**FILE** P. I. No. 0007916, Clayton County **OFFICE** Preconstruction  
CSMSL-0007-00(916)  
Lamar Hutcheson Parkway Park and Ride Lot **DATE** January 31, 2006

**SUBJECT** APPROVED PROJECT CONCEPT REPORT

Lamar Hutcheson Parkway Park and Ride Lot  
Clayton County

**Subject:** CONCEPT MEETING MINUTES – Lamar Hutcheson Park & Ride Lot - GRTA

STATE OF GEORGIA  
DEPARTMENT OF TRANSPORTATION  
OFFICE OF URBAN DESIGN  
CONCEPT PLAN

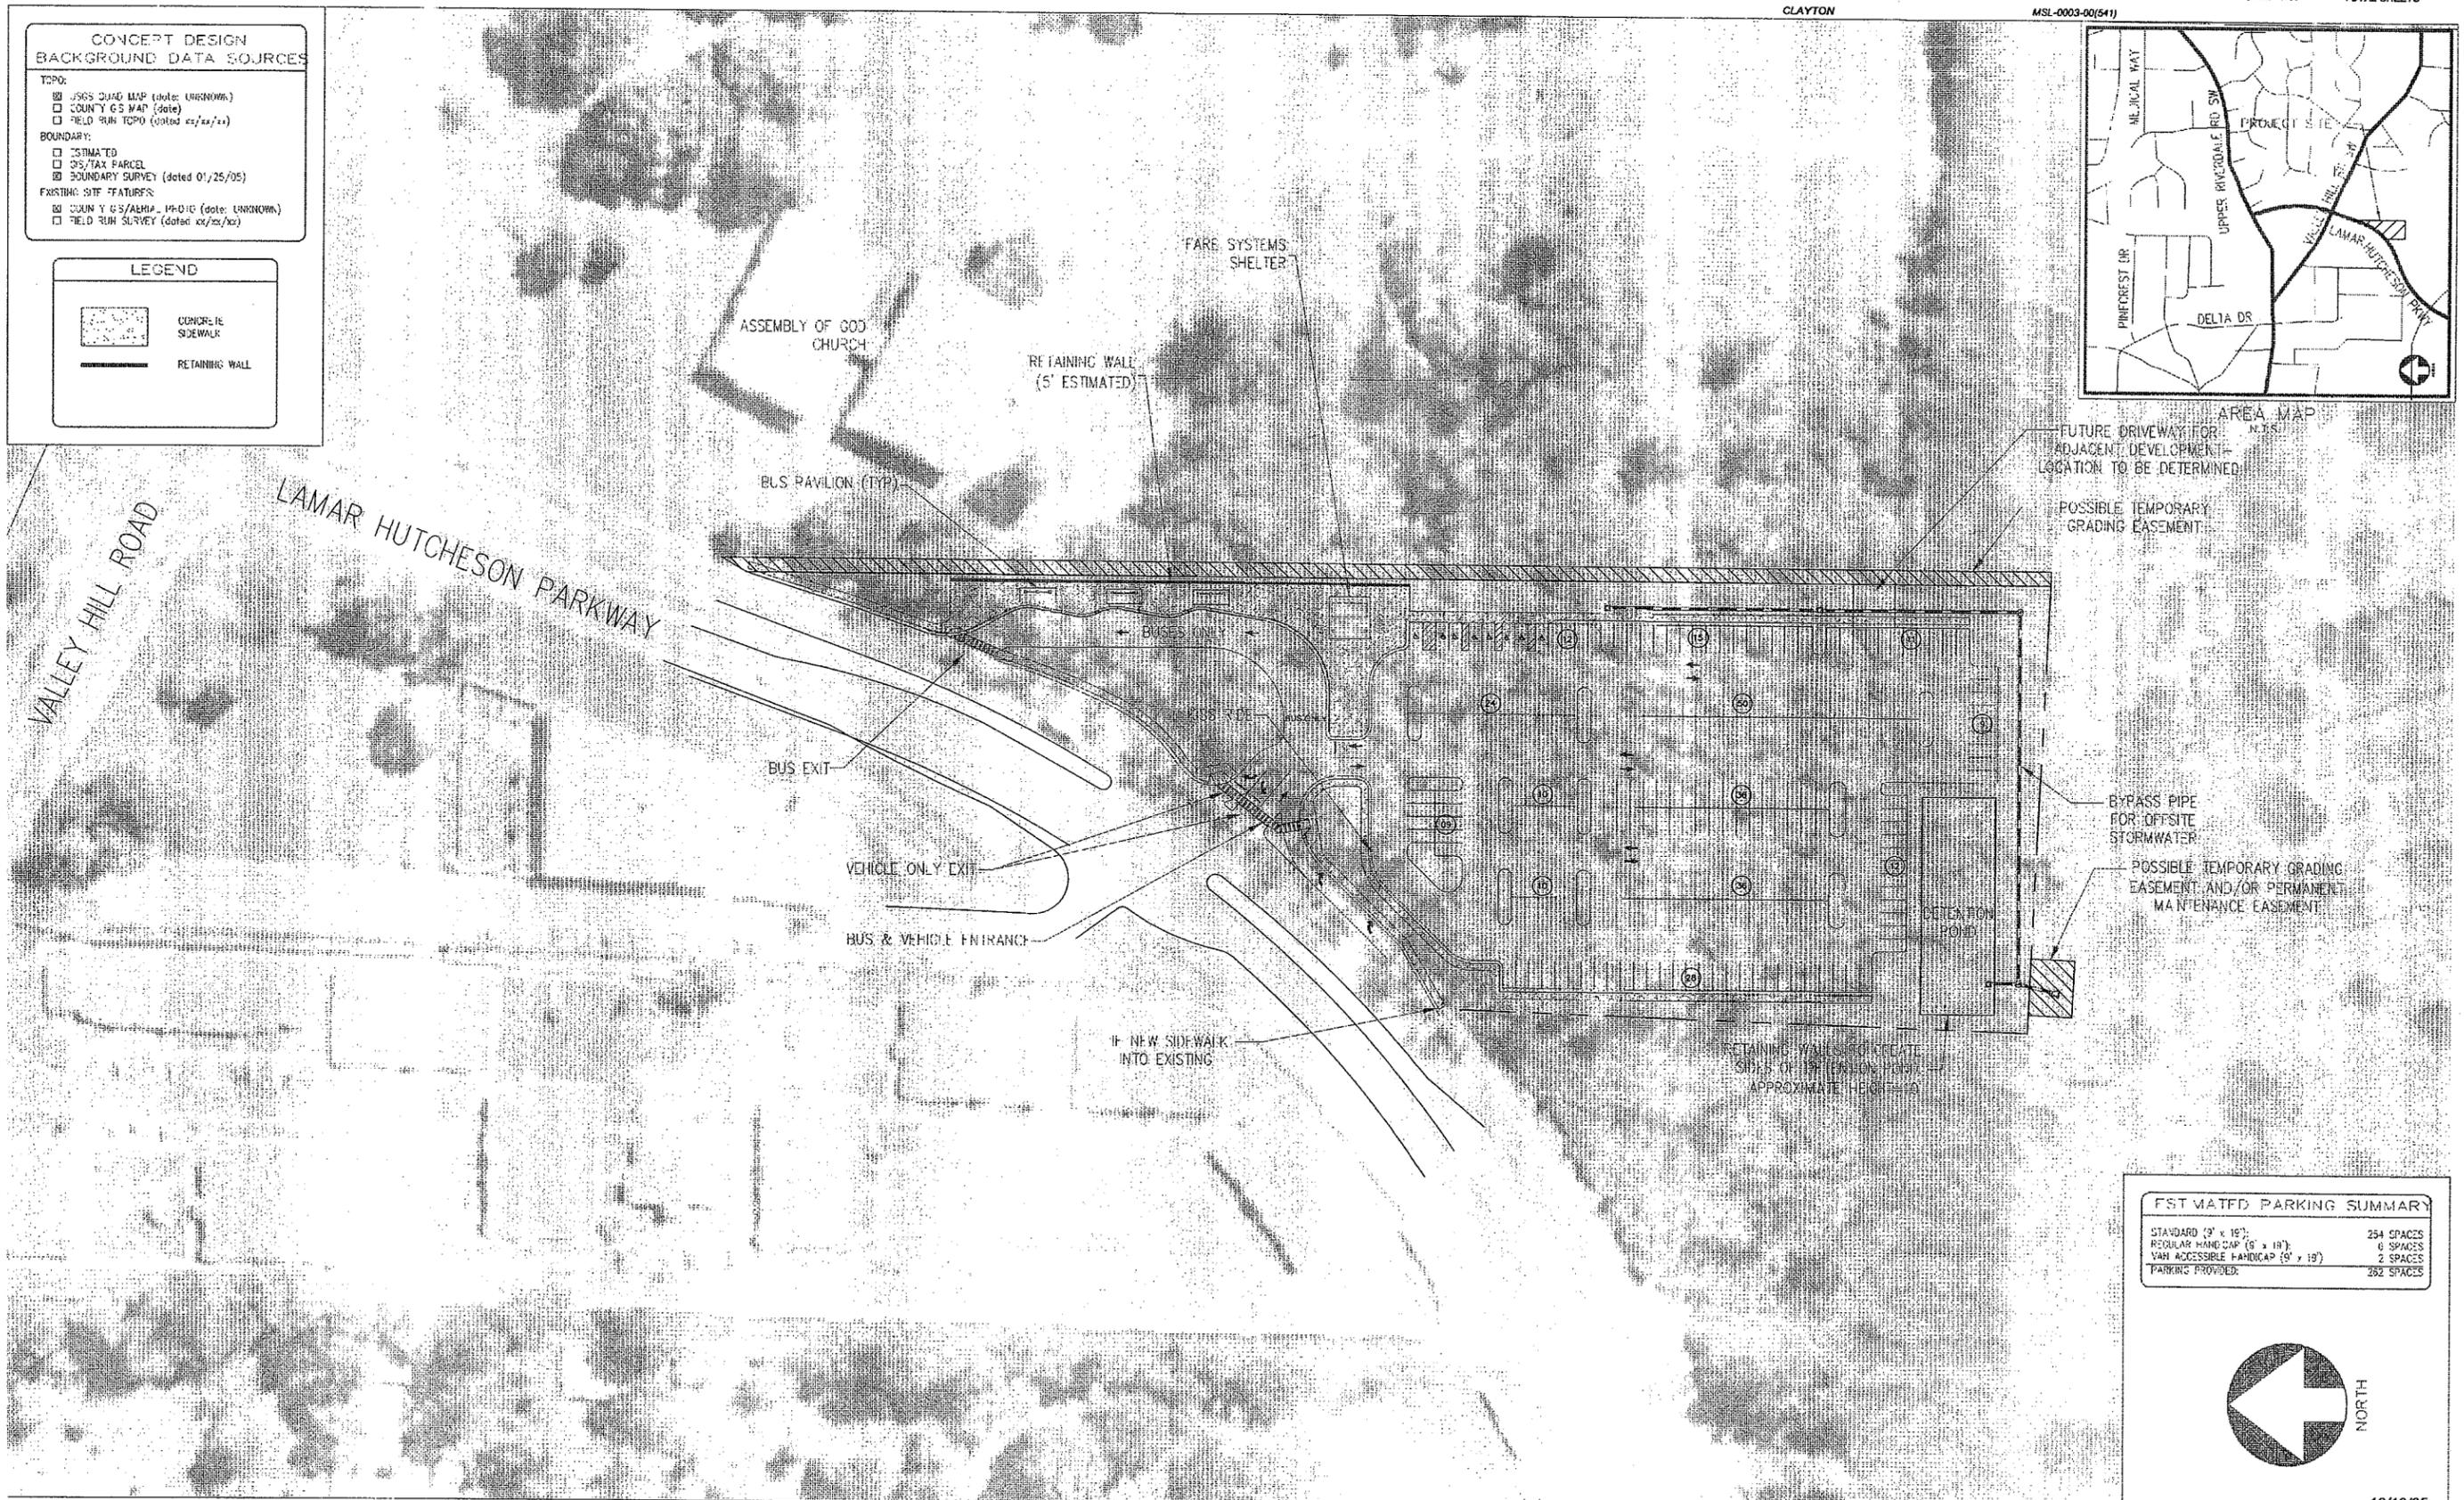
**Comment:** GDOT expressed concern over the sharp angle of the exit drive in reference to bus drivers not being able to see clearly while looking over their left shoulders.

**Comment:** GDOT stated that the two lane exit shown on the concept plan may be hazardous. Concern was expressed that two vehicles exiting at the same time, in the same direction may collide with each other.

**Comment:** Clayton County DOT requested that the following elements be included in the design:

- Deceleration lane for entering vehicles
- Sidewalks along property frontage. Tie into existing sidewalks
- Relocated vehicle exit to enable commuters to use existing median break for left turn movements.

**Comment:** GDOT requested that the KISS ride be relocated away from the bus drop-off.

**Response:** URS/GRTA believes that bus drivers will have a clear view of oncoming traffic at the present angle of the driveway. However, URS will revise the driveway with a lessened angle.

**Response:** URS agrees and will modify the concept plan such that vehicles and buses do not share the same exit. In addition, the concept will be revised so that the vehicle and bus *entrances* are also separated. The buses and vehicles will not share any drives in the revised concept.

**Response:** URS will modify the concept plan according to each of Clayton County's requests (see revised concept plan)

**Response:** URS agrees and will relocate the KISS ride to a location within the parking area (see revised concept plan).
